ITS CORPORATION			REV	ECN	DATE	APV
THIS PRINT IS THE PROPERTY OF ITS CORP. IT SHALL NOT BE COPIED WITHOUT PERMISSION.			TITLE			
			SCHMEMATIC, AMP./ATTENUATOR MODULE MMDS (1132-1509)			
MATERIAL			DWN	JCM	11/21/91	DWG. NO.
FINISH			CHK	JCM	11/14/91	1132-3509
			REL	JCM	11/14/91	REV
			SCALE ---		SHEET 1 OF 1

ITS CORPORATION				REV	ECN	DATE	APV
REV	ECN	DATE	APV	THIS PRINT IS THE PROPERTY OF ITS CORP. IT SHALL NOT BE COPIED WITHOUT PERMISSION.			
				MATERIAL			
				FINISH			
TITLE				SCHEMATIC – BROAD BAND CAVITY FILTER, 3 SECTION (1107–1101)			
DWN		JEO	6/27/88	DWG. NO.		REV	
CHK		RE	6/29/88	1107–3101		0	
REL		RE	6/29/88	A	SCALE ---	SHEET 1 OF 1

ITS CORPORATION				REV	ECN	DATE	APV
THIS PRINT IS THE PROPERTY OF ITS CORP. IT SHALL NOT BE COPIED WITHOUT PERMISSION.				TITLE SCHEMATIC - TRANSMITTER CONTROL BD. (1510-1104)			
				DWN	KEF	3-28-94	DWG. NO.
MATERIAL				CHK	CAR	5/10/94	1510-3104
FINISH				REL	KEF	11/17/94	2
				SCALE ---		SHEET 1 OF 1

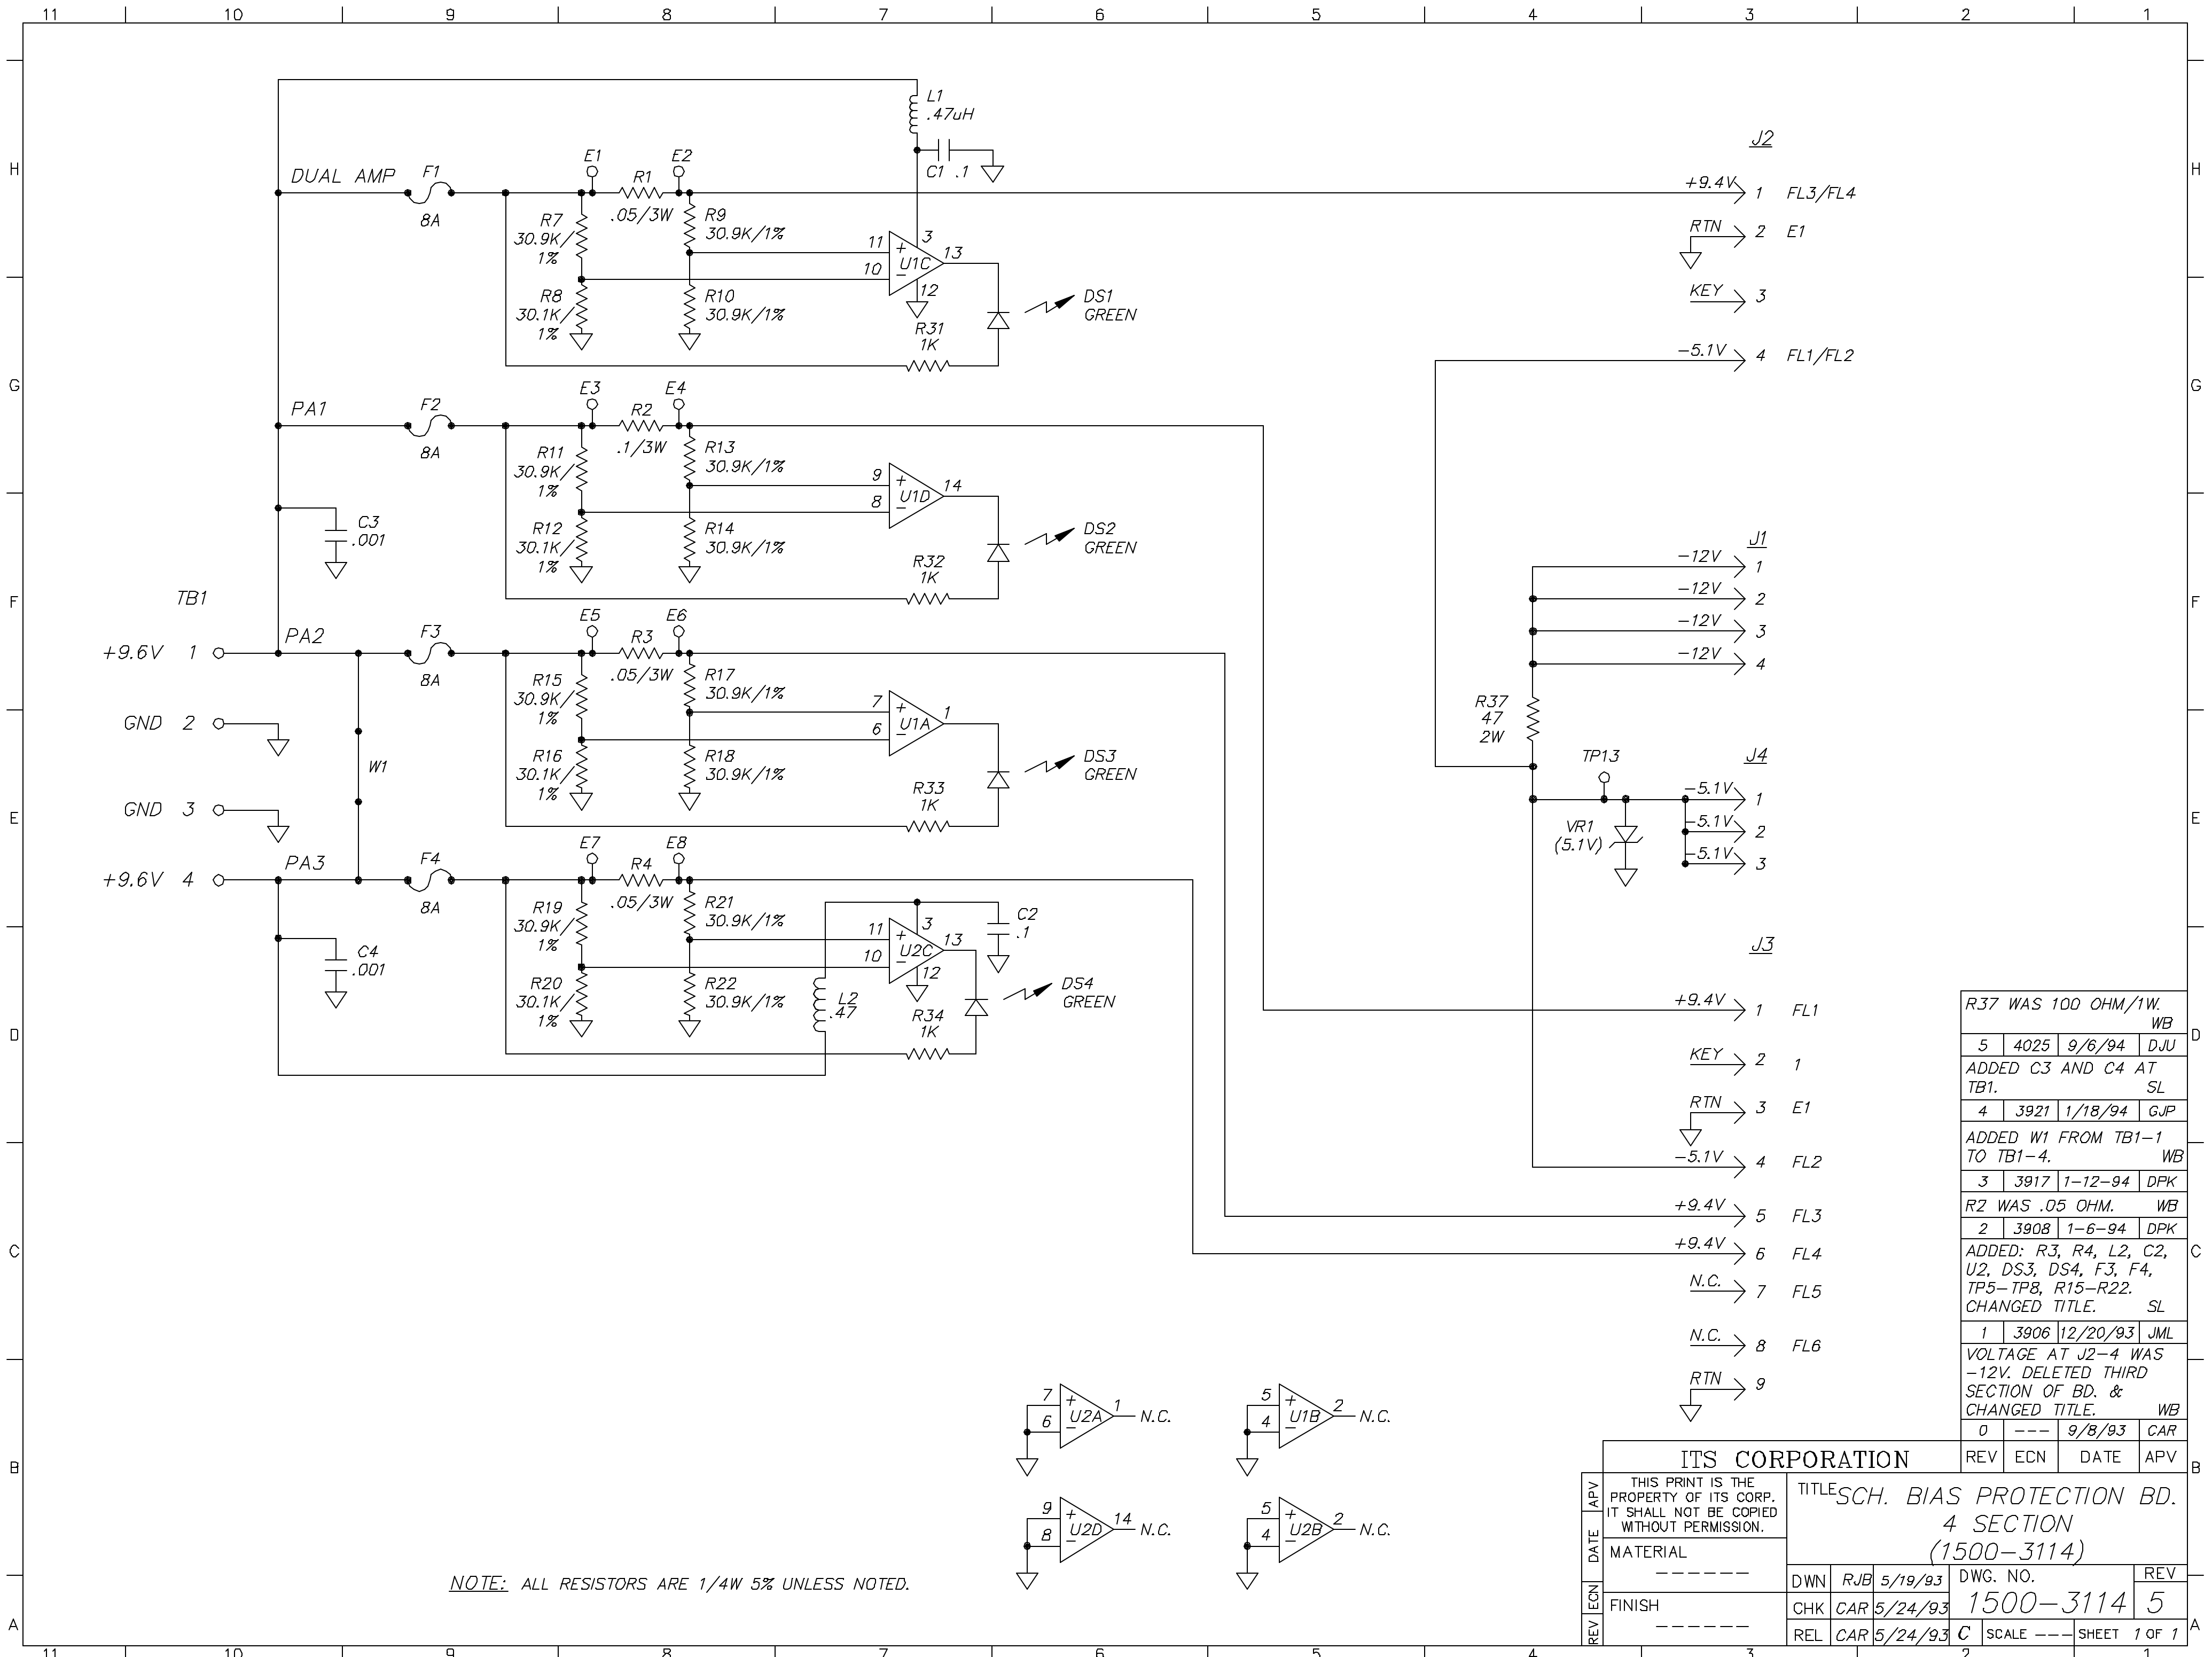
R37 WAS 100 OHM/1W.				WB
5	4025	9/6/94	DJU	
ADDED C3 AND C4 AT TB1.				SL
4	3921	1/18/94	GJP	
ADDED W1 FROM TB1-1 TO TB1-4.				WB
3	3917	1-12-94	DPK	
R2 WAS .05 OHM.				WB
2	3908	1-6-94	DPK	
ADDED: R3, R4, L2, C2, U2, DS3, DS4, F3, F4, TP5-TP8, R15-R22.				SL
CHANGED TITLE.				
1	3906	12/20/93	JML	
VOLTAGE AT J2-4 WAS -12V. DELETED THIRD SECTION OF BD. & CHANGED TITLE.				WB
0	---	9/8/93	CAR

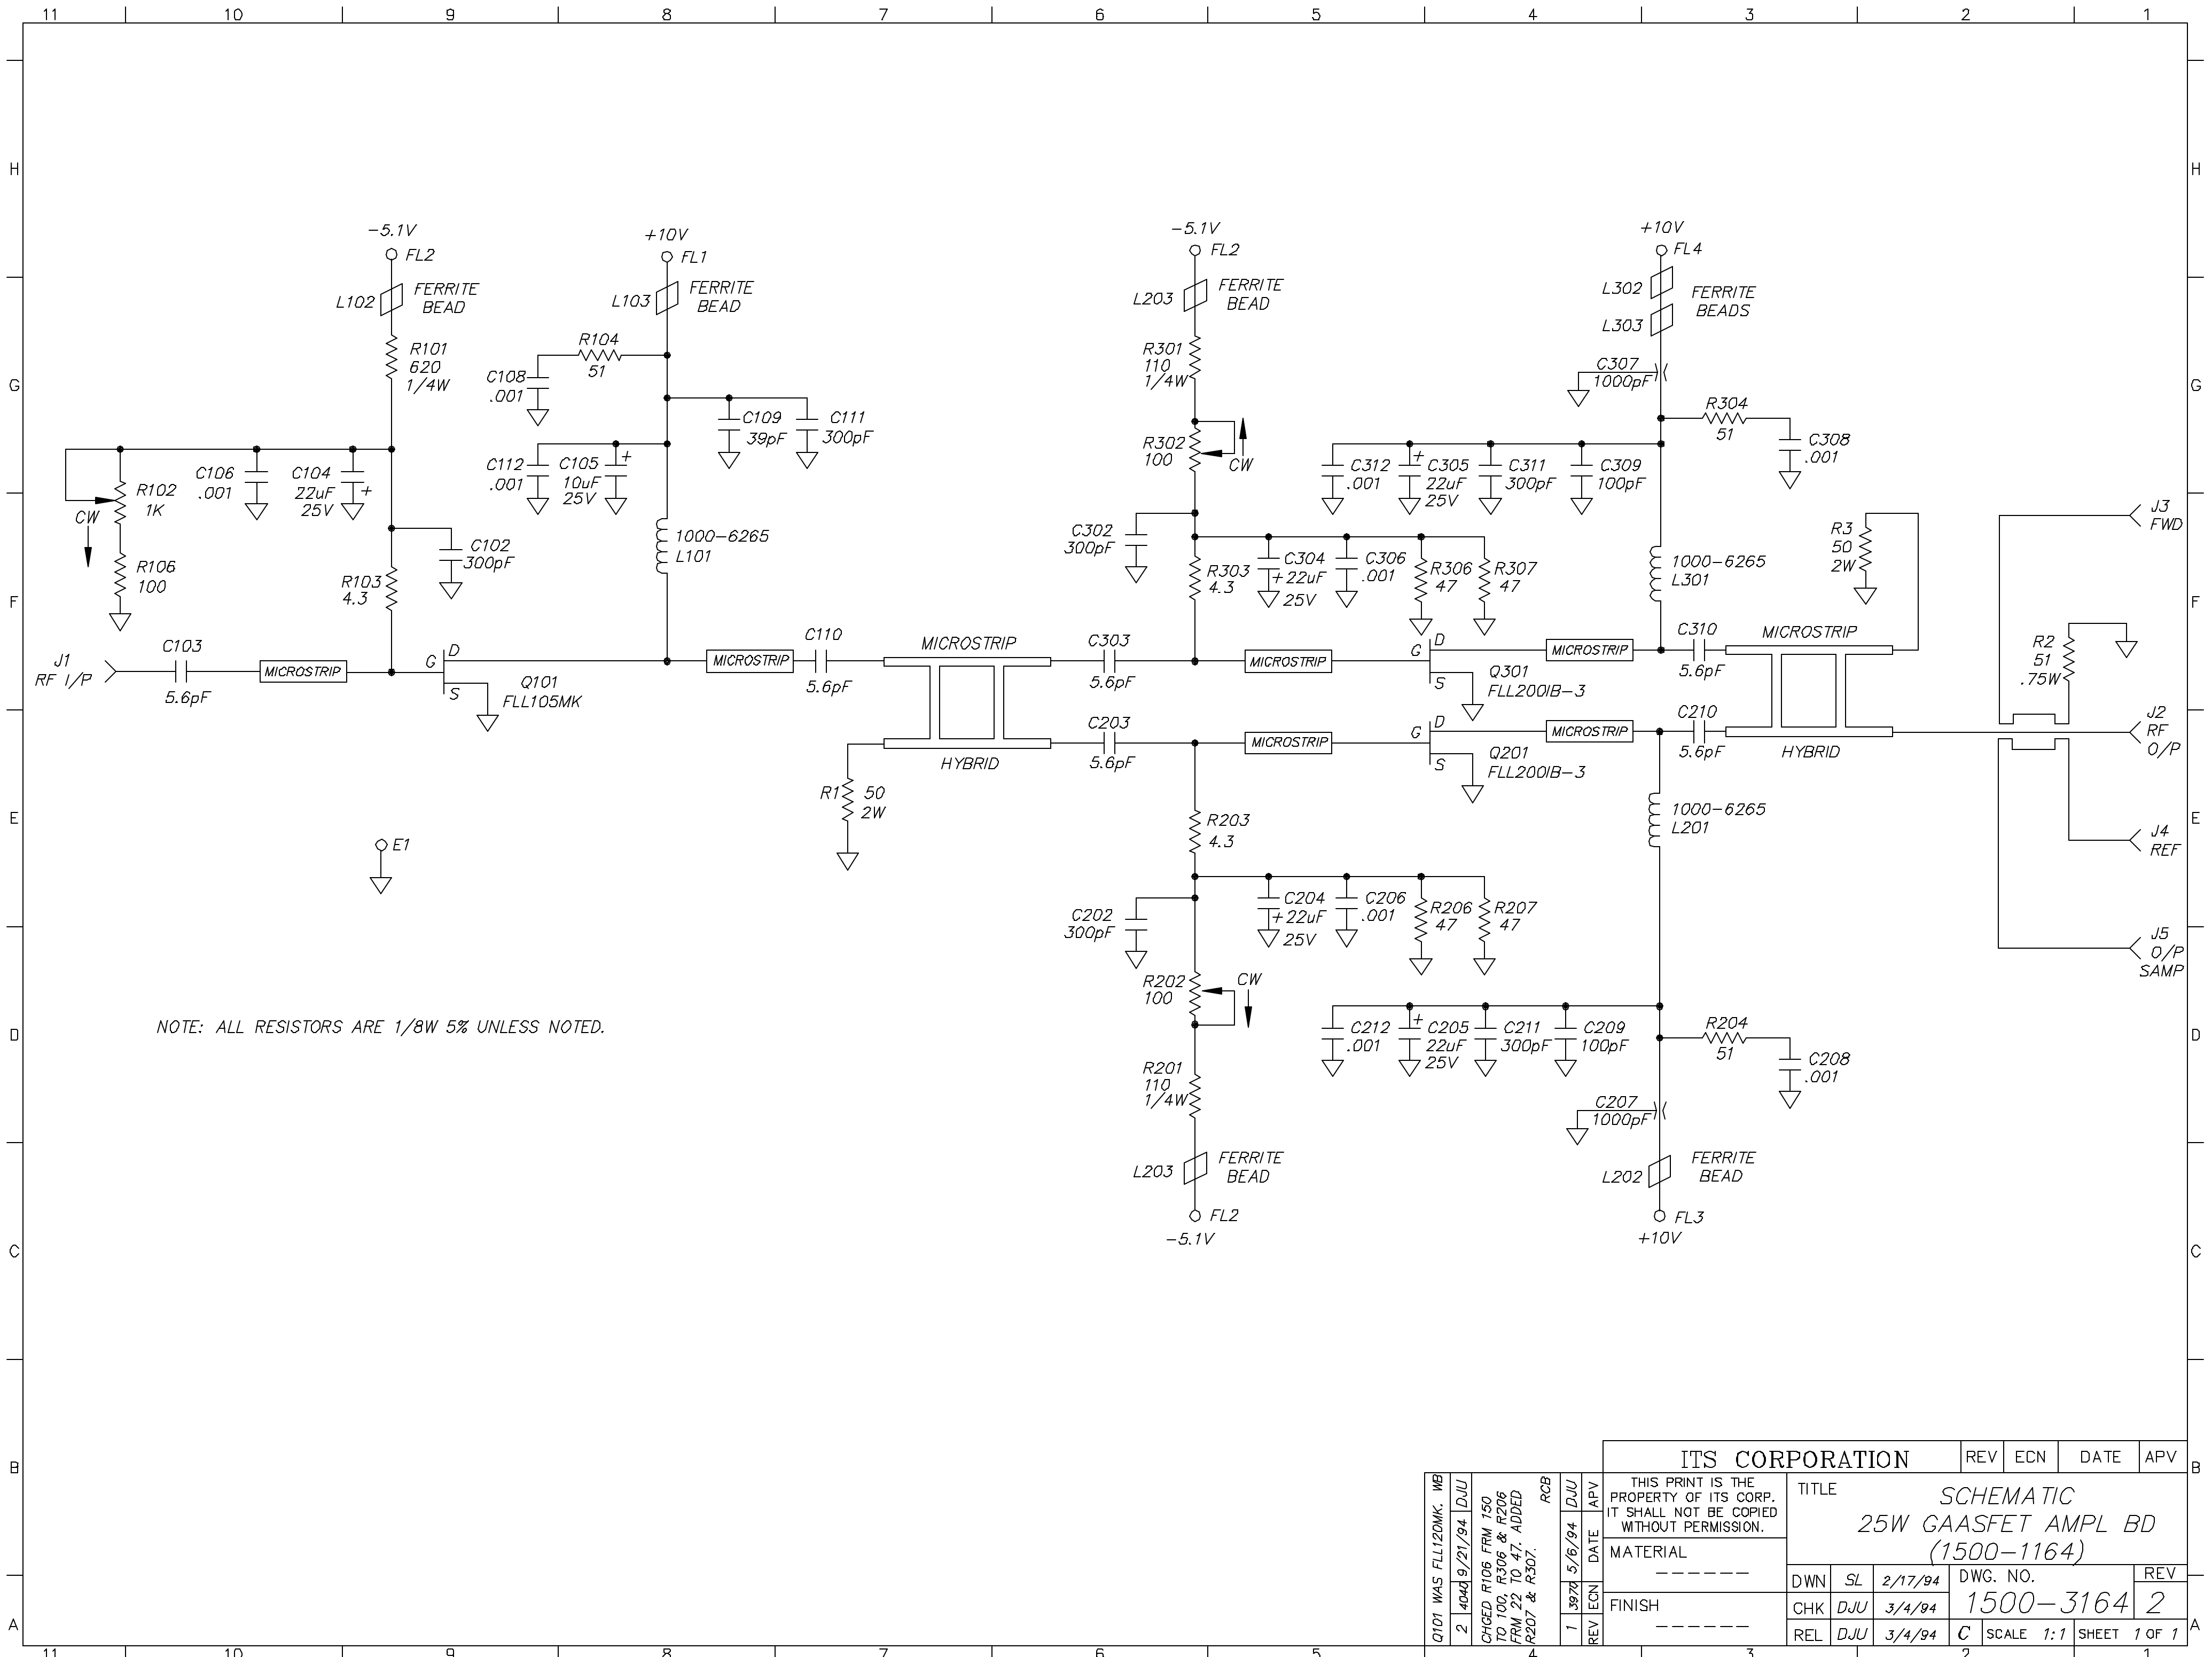
Q101 WAS FLL120MK. WB				RCB				THIS PRINT IS THE PROPERTY OF ITS CORP. IT SHALL NOT BE COPIED WITHOUT PERMISSION.				TITLE			
2	1404d	9/21/94	DJU	CHGED R106 FRM 150 TO 100, R306 & R206 FRM 22 TO 47. ADDED R207 & R307.	1	397d	5/6/94	DATE	APV	SCHEMATIC				REV	ECN
								MATERIAL				25W GAASFET AMPL BD			
								FINISH				(1500-1164)			
								DWN				DWG. NO.			
								CHK				1500-3164			
								REL				2			
								SCALE				1:1			
								SHEET				1 OF 1
